ARCHITECT'S PROJECT #1708 4J SCHOOL DISTRICT JOB #177662
4J SCHOOL DISTRICT
NORTH EUGENE HIGH SCHOOL
TRACK SHED
200 SILVER LANE
EUGENE, OREGON 97404

This addendum, consisting of a total of (3) pages, forms a part of the Contract Documents and modifies the original Drawings dated July 10, 2017.

PLANS, SCHEDULES, & SECTION

PROJECT NUMBER 1708
 DRAWN AMB
 CHECKED LRB
 DATE 7/24/2017
 REVISIONS
 No. Description Date
 1 ADDENDUM 1 7/24/2017
 SHEET NUMBER
A2

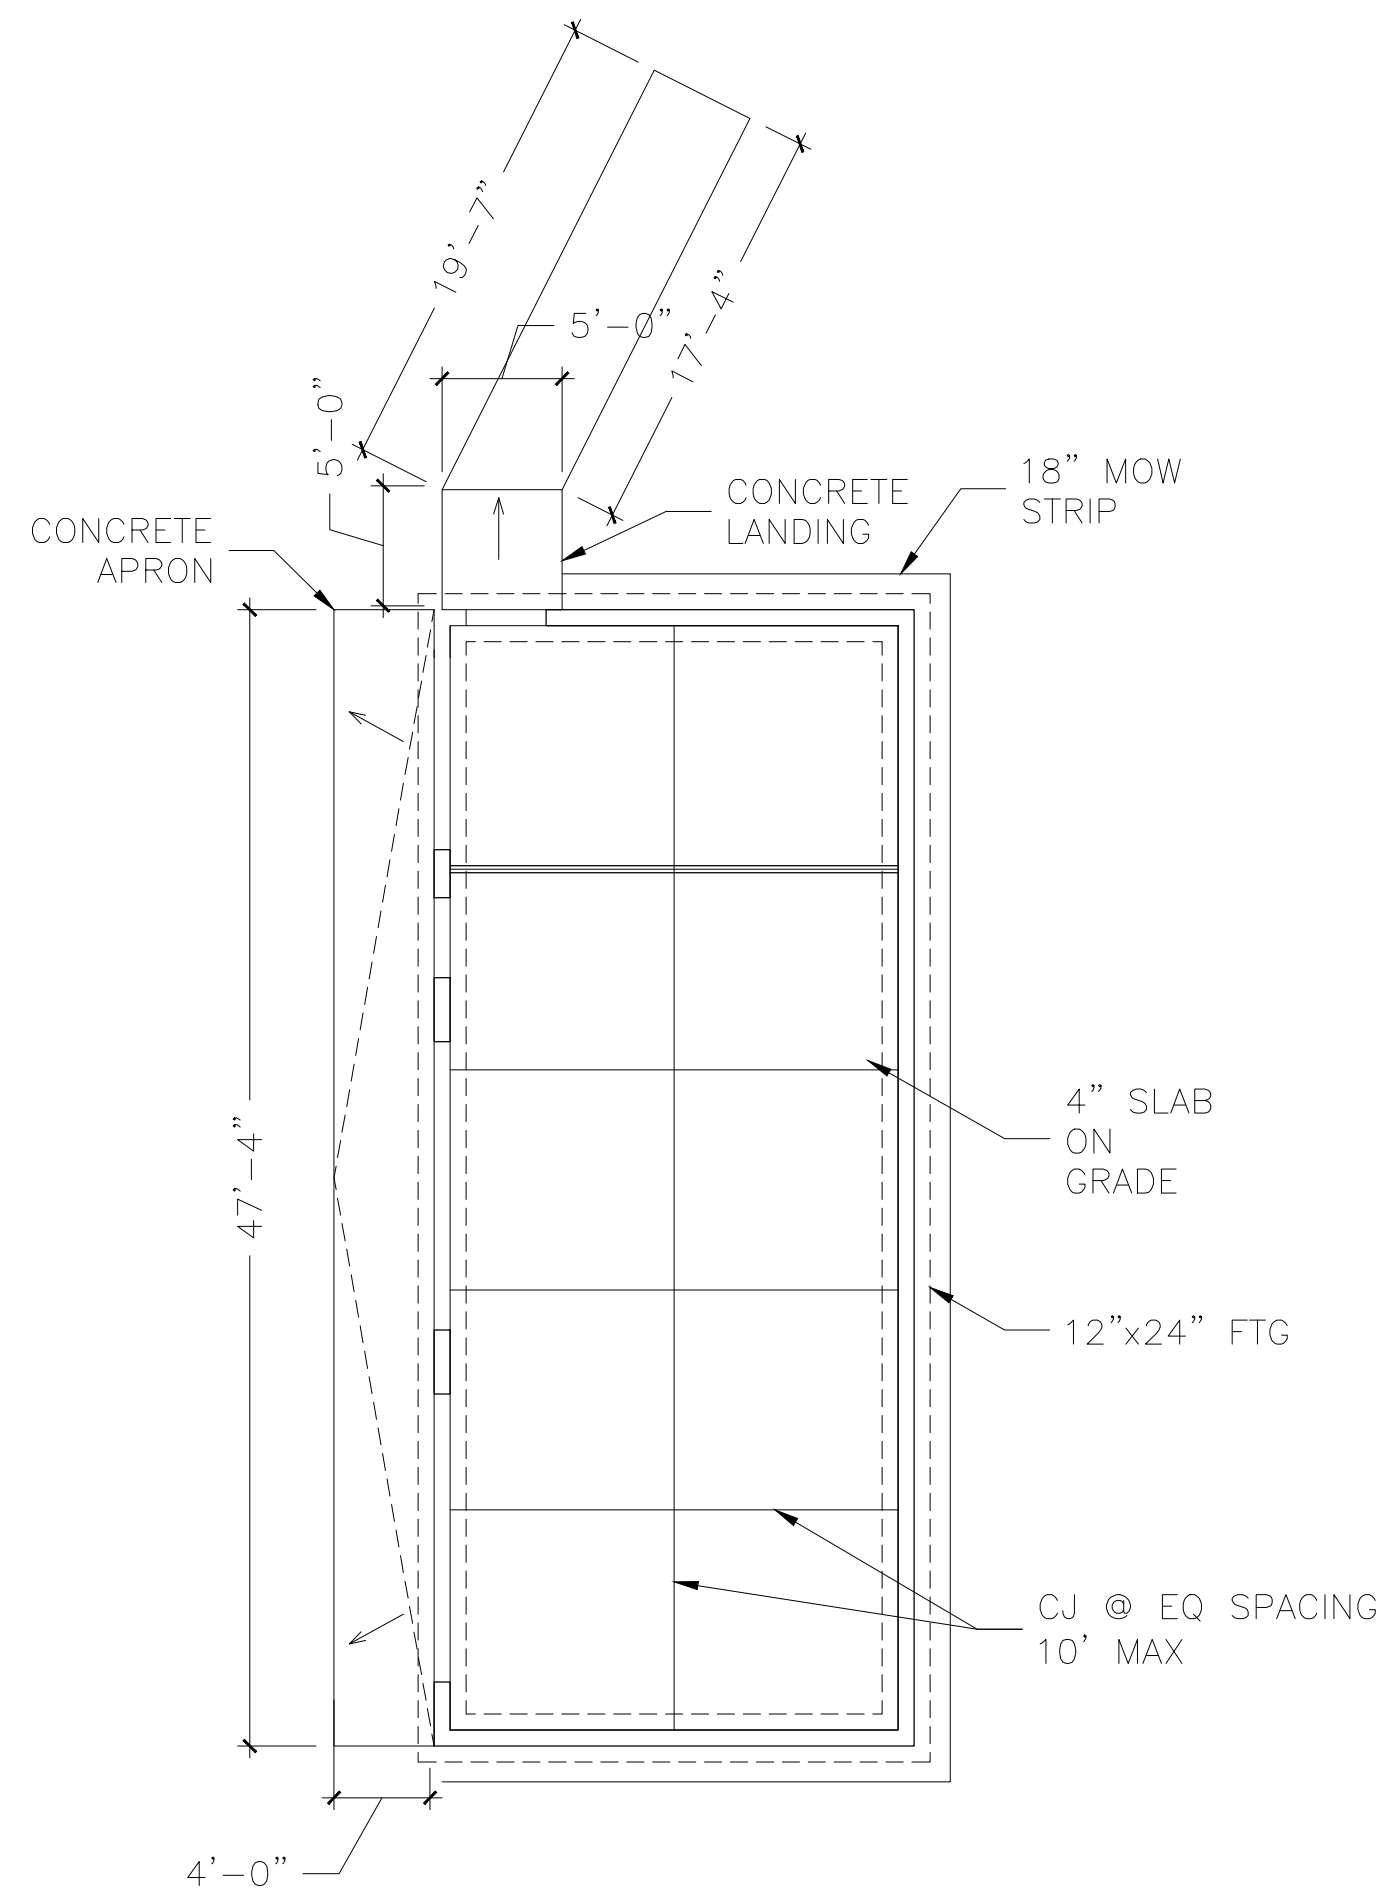
Correction to door schedule on sheet A2

Q1: The door schedule states entry doors as factory finish. The painting spec says they are Churchill Red. Do they come factory finished in this color?

A1: *No, the door schedule has been corrected*
